SYDNEY NORTH PLANNING PANEL COUNCIL ASSESSMENT REPORT

Panel Reference	PPSSNH-302
DA Number	DA2021/2600
LGA	Northern Beaches Council
Proposed Development	Thirteen (13) lot subdivision, civil and creek line works and construction of integrated residential development including two (2) residential flat buildings containing thirty-four (34) apartments.
Street Address	43, 45, 49 Warriewood Road Warriewood
Applicant	Creative Planning Solutions Pty Ltd
Owner	Warriewood Developers Pty Ltd
Date of DA lodgement	14/01/2022
Number of Submissions	26
Recommendation	Refusal
Regional Development Criteria (Schedule 7 of the SEPP) State and Regional Development) 2014	Designated development and partly owned by Council with capital investment value over \$5 million Total Cost of the Development is <u>\$20,348,417</u>
List of all relevant s4.15(1)(a) matters	<ul style="list-style-type: none"> • Environmental Planning and Assessment Act 1979 • Environmental Planning and Assessment Regulation 2021 • State Environmental Planning Policy (Planning Systems) 2021 • State Environmental Planning Policy (Transport and Infrastructure) 2021 • State Environmental Planning Policy (Resilience and Hazards) 2021 • Sta

Figure 4 – Site analysis plan (source: Archidrome)

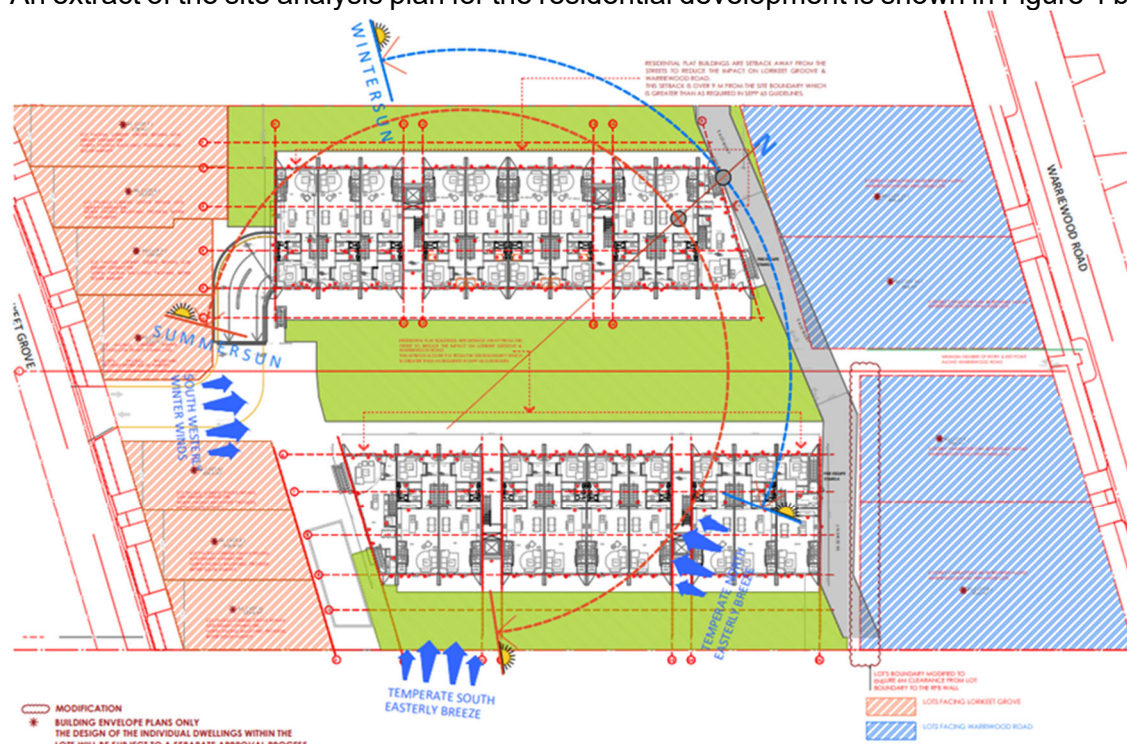
Level 1 and 2 of each RFB contains ten x two-storey 'terrace' style apartments. They are directly accessible from ground level and from the individual garages within the basement. Private open space areas for the terrace apartments is provided at ground level.
